Re: Kentucky-American Water Company
Bluegrass Water Project

Enclosed are two copies of Addendum No. 1 for the referenced project. Changes to the original pages are highlighted by a vertical line in the left hand margin with additions in blue italic print and deletions in red strike-through print. The addendum number is also indicated in the top margin of each page which contains revisions. Please note that some pages do not include any revisions and are only being submitted in order to keep the pages in proper sequential order.

Specifically, this addendum includes the following:

Revised per Addendum No. 1

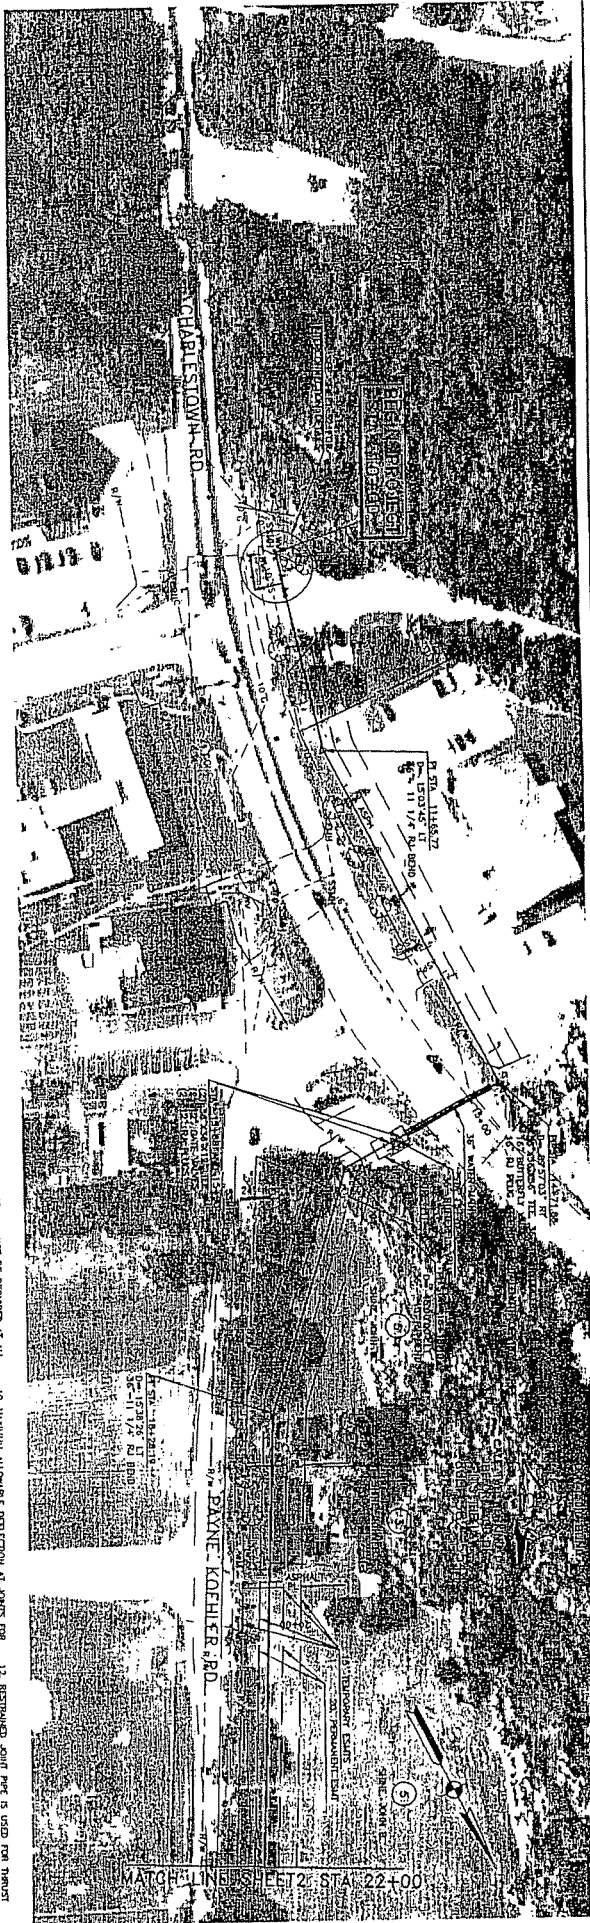
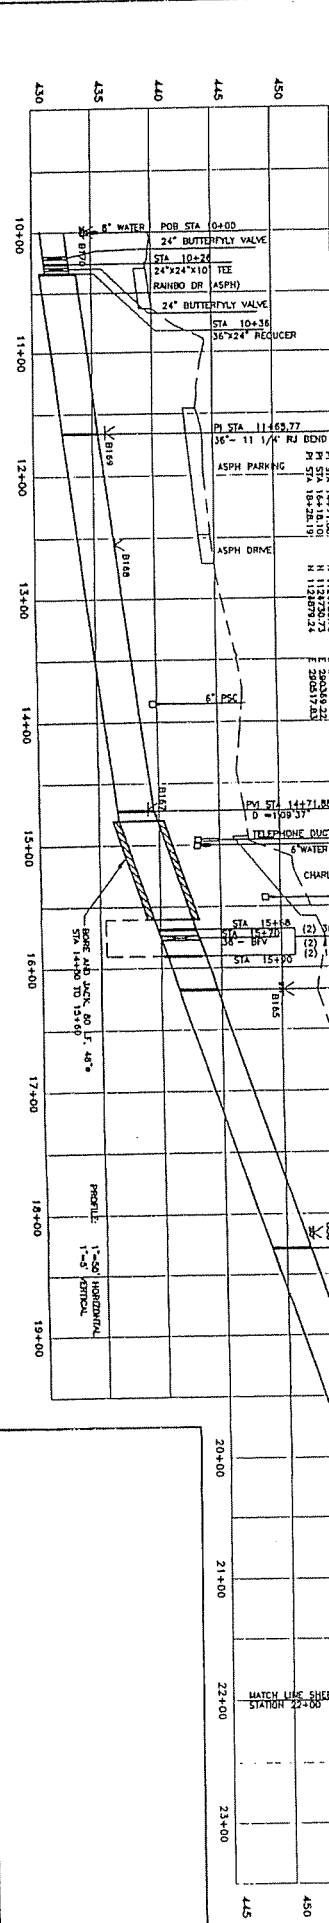
- Revisions to the cover page of Attachment C.
- An "Example Plan and Profile Pipeline Drawing" for Attachment C.
- Revisions to the cover page of Attachment D.
- A "Tie In Point at the KAWC Distribution System" drawing for Attachment D.

Pipeline plan drawings are required along the entire route, and shall be prepared as strip maps on aerial photographs *at a scale of 1" = 50' and include centerline staking, easements, and property lines.* The aerial photographs, *which were taken in 1994 and are at a scale of 1" = 350',* will be provided by the Water Company. Pipeline profile drawings are only required at locations involving utility, roadway, railway, or waterway crossings, or where unique or extraordinary pipeline support is necessary, *and shall be at a scale of 1"=5'.* For the purposes of the proposal, the Consultant shall assume that 10% of the pipeline route will require both plan and profile drawings. *An example pipeline drawing is provided in the Attachments.*
